BENTON COUNTY COMMUNITY PATHWAYS

OPEN HOUSE #2 SUMMARY

Lighting

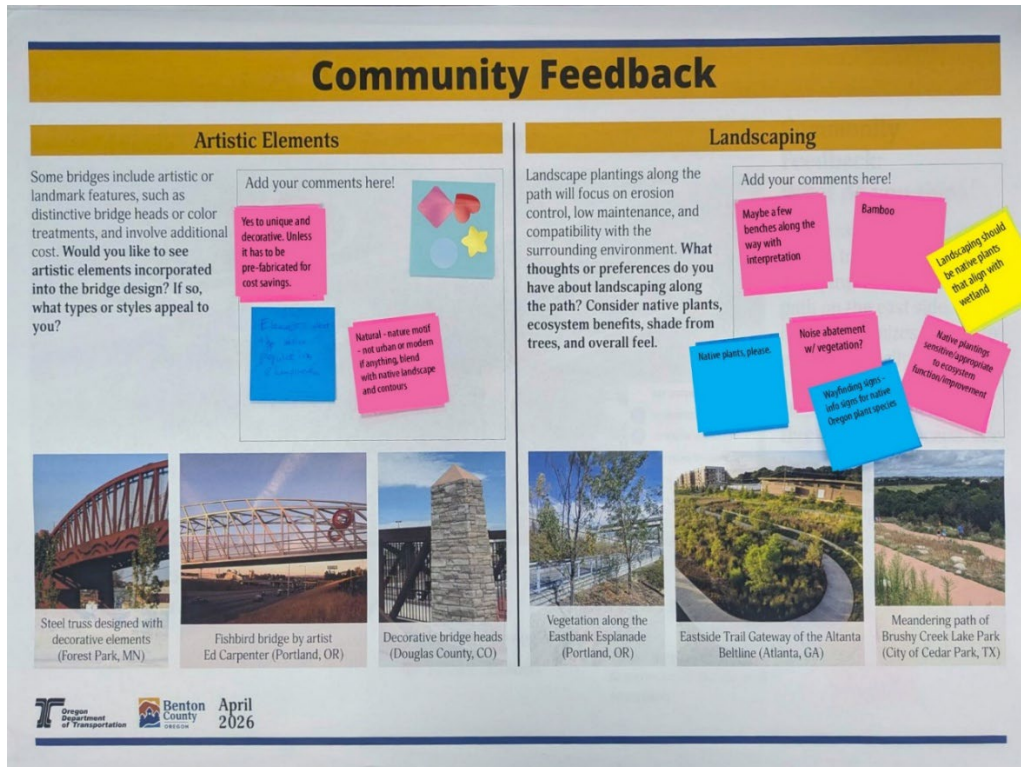
- Shield lighting- no glare
- Minimize lighting to path- avoid wildlife
- Shield lights to avoid glare and bothering wildlife
- Minimize lighting that disturbs night sky and animals but optimize safety of pedestrians and cyclists
- Dark sky lighting/ Pedestrian oriented
- No lights! Dark sky! Necessary for wildlife- crepuscular wildlife especially

Recommended Design

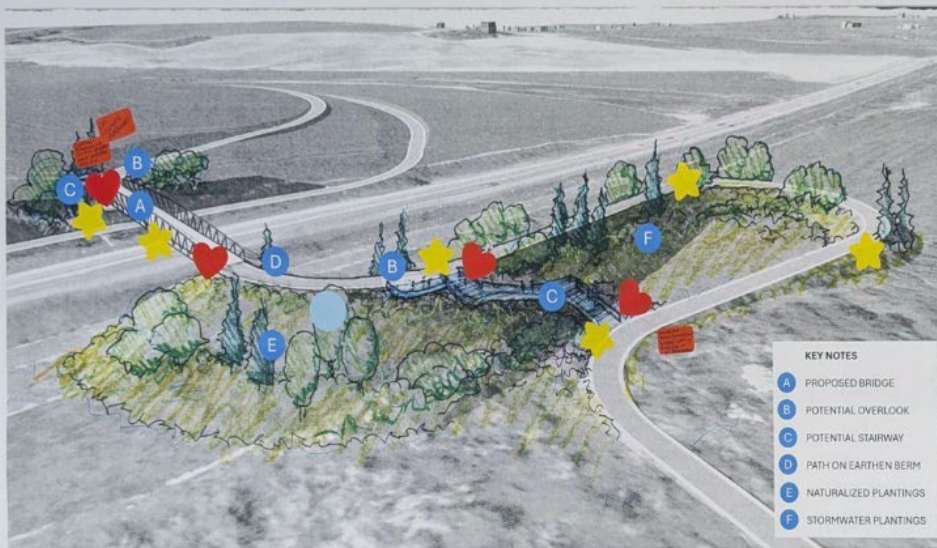
Don't need lighting - low pathway lights ok but not really needed at all
